## JOINT REGIONAL PLANNING PANEL (Sydney East Region)

<b>JRPP Reference Number</b>	<b>2011SYE21</b>
<b>DA Number</b>	<b>2011000072</b>
<b>Local Government Area</b>	<b>Marrickville Council</b>
<b>Proposed Development</b>	<b>To retain the existing facade along Enmore Road, demolish the remainder of the existing improvements and erect a mixed use development containing thirty-six (36) dwellings and 210sqm of cafe/food tenancies over a basement carpark which is to contain twenty-five (25) off street parking spaces.</b>
<b>Street Address</b>	<b>21-23 Enmore Road and 1 Crescent Lane, Newtown</b>
<b>Applicant/Owner</b>	<b>Platino Properties</b>
<b>Number of Submissions</b>	<b>Twenty-five (25)</b>
<b>Recommendation</b>	<b>Refusal</b>
<b>Report by</b>	<b>Sophia Chin, Development Assessment Officer</b>

### Assessment Report and Recommendation

Image 29: Eastern Elevation Plan

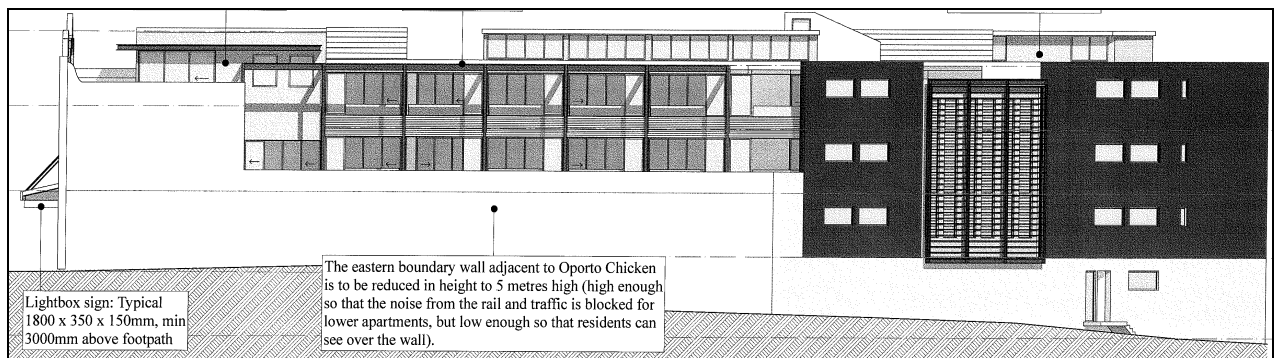
Given the height relationship between the proposed building and the adjoining Oporto Chicken site to the east, the side walls of the proposed building would be highly visible from Enmore Road as illustrated in the side elevation plan illustrated in *Image 29: Eastern Elevation Plan* earlier in this report.

*Image 32: Lot 1 DP 1160729 zoned B2 Local Centre under draft MLEP 2011*

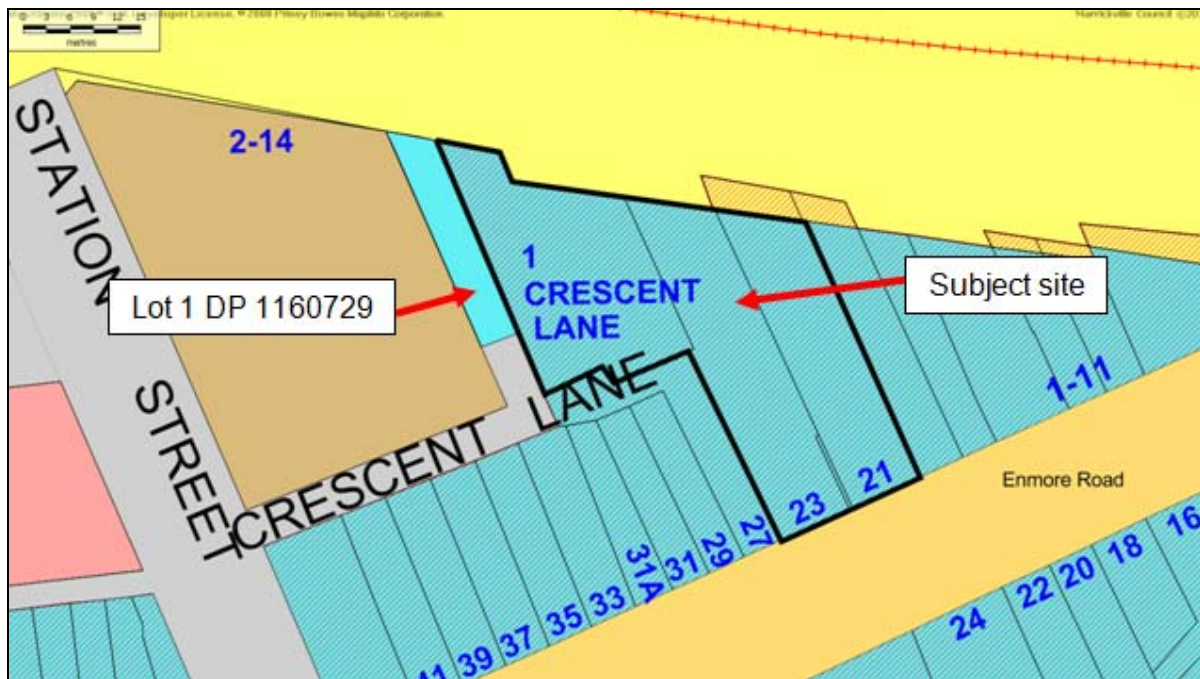
As a result of the part closure of Crescent Lane the current proposal is unsatisfactory in its current form and the plans will need to be amended to remove all proposed vehicular and pedestrian access to the closed portion of Crescent Lane including access to the 3 ground floor units adjacent to the closed lane and the proposed egress from the fire escape that leads to the closed portion of Crescent Lane.

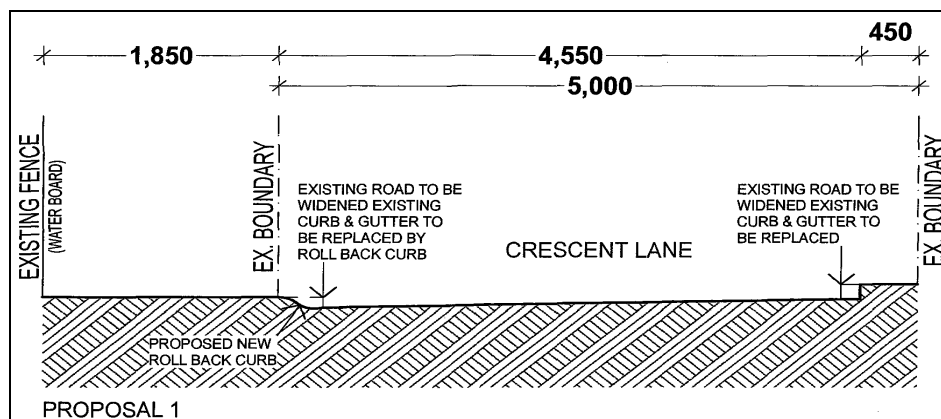
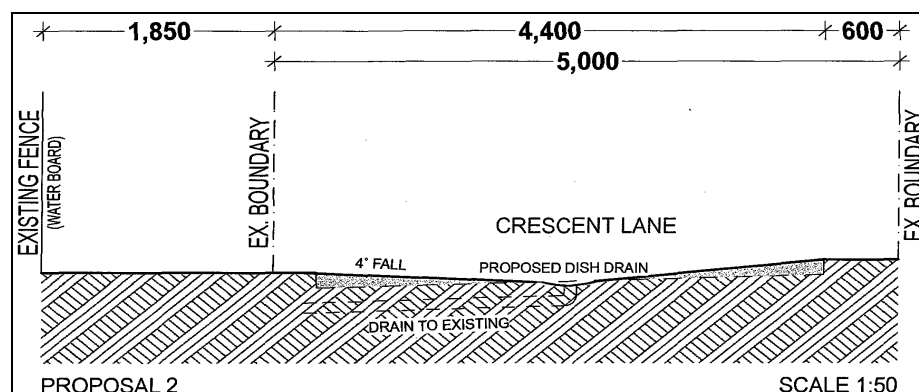
- *Currently parking is permitted on one side of Crescent Lane prior to the proposed entry to the development. If cars are parked in the lane then the space available for vehicles to pass is approximately 1.96 metres, which is inadequate. The deletion of these car spaces should be considered as part of the traffic assessment to provide adequate 2 way movements in Crescent Lane. (Minimum width of a parallel car space is 2.1 metres as per AS2890.5). Please note that this will require referral to the Local Traffic Committee.*

*With respect to this proposal, Council's engineer raised the concern that vehicles could park too close to the fences. In this regard we note that over 50% of the laneway is presently occupied by crossings. An alternative would be to provide a roll top kerb or crossing along the whole of the Eastern side of the lane.*

*This will allow a 2.1 metre wide space for parallel parking a car adjacent to the Eastern side of the Lane (as per Australian Standards) and a space 2.45 metres wide for vehicles to pass by. It is noted that 2.45 metres is the width of a regular car parking space as per Australian Standards and is in practice, adequate to allow a car to pass another parked car. In other words, if a car can be parked in a car space, a car can drive through a gap of similar width.*

*Proposal 2 in the attached diagram (as recommended by our traffic consultant, Robert Varga) shows the road raised along the edges in to eliminate the kerbs and would provide a trafficable laneway width of 5.0 metres.*

*Either Proposal 1 or 2 represents a great improvement on the existing situation by increasing the width of the roadway within the existing road reserve and either proposal will allow adequate access. These improved traffic arrangements would also benefit the 10 properties (not including the applicant's property) that presently have access from Crescent Lane.*

Image 33: Proposed Shareway

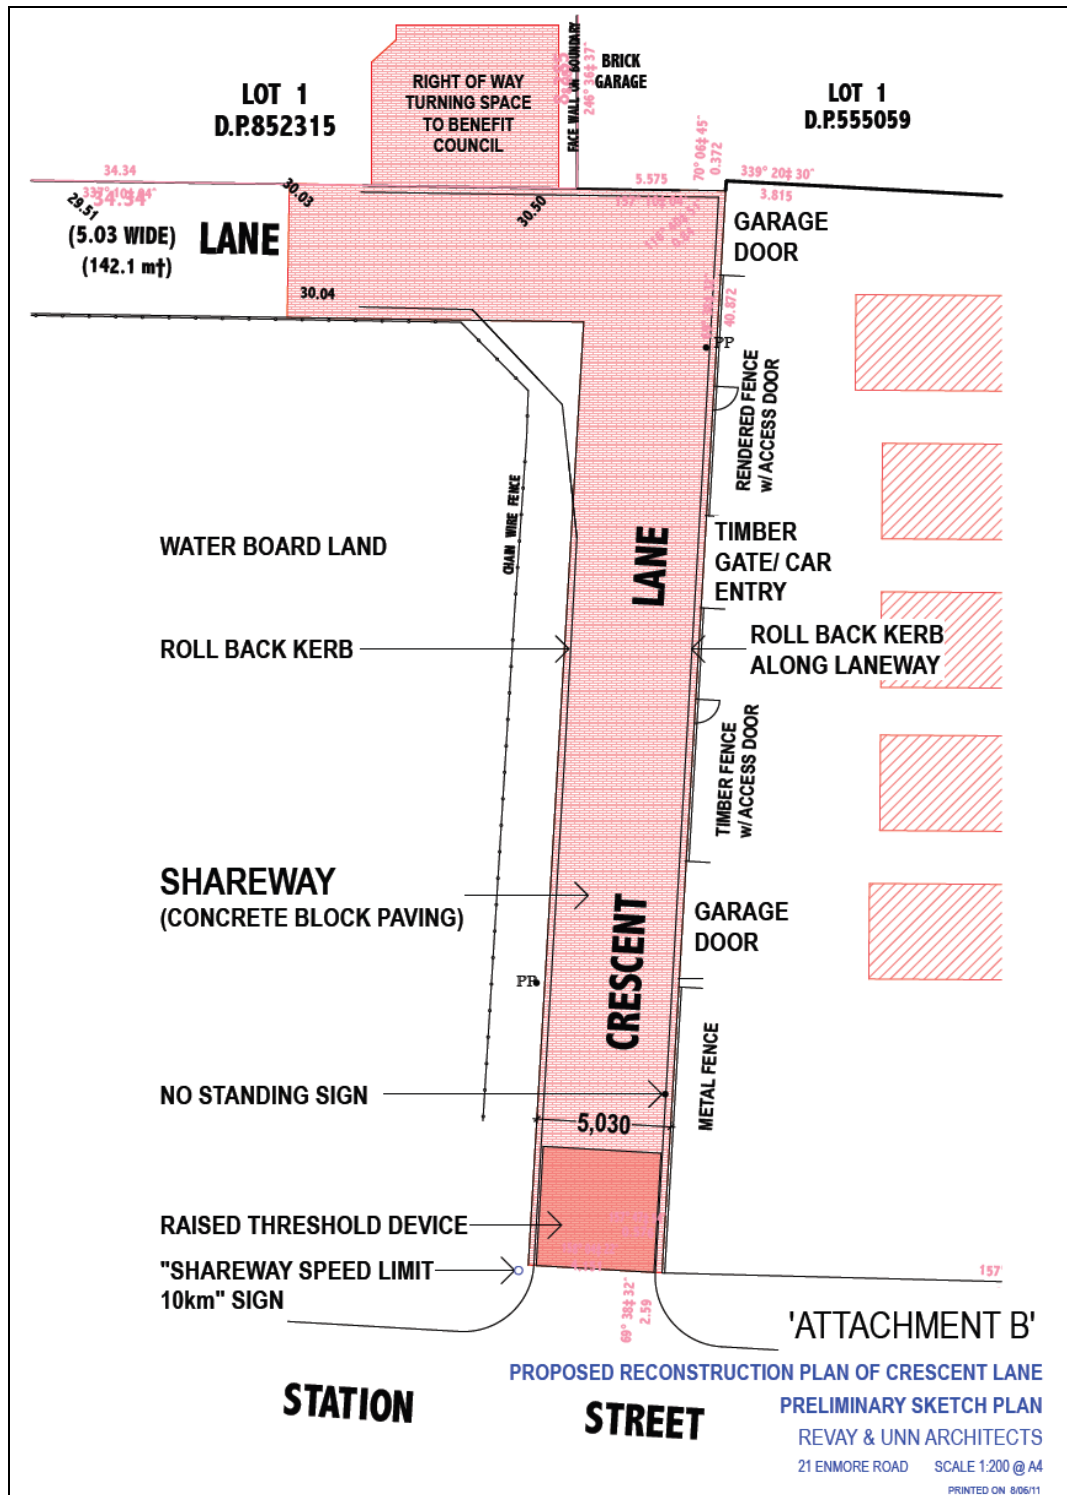
As stated above, the proposed development seeks approval to convert the east-west section of Crescent Lane, between Station Street and the driveway crossing of the proposed development site to a Shared Zone, in order to facilitate vehicular access for the proposed development. Council's Local Traffic Planning and Advisory Committee raised no objection in principle to the proposed Shared Zone subject to conditions. However the Roads and Traffic Authority is the responsible authority for determining whether or not to approve the proposed Shared Zone. At the time of writing this report the RTA's approval had not been obtained.
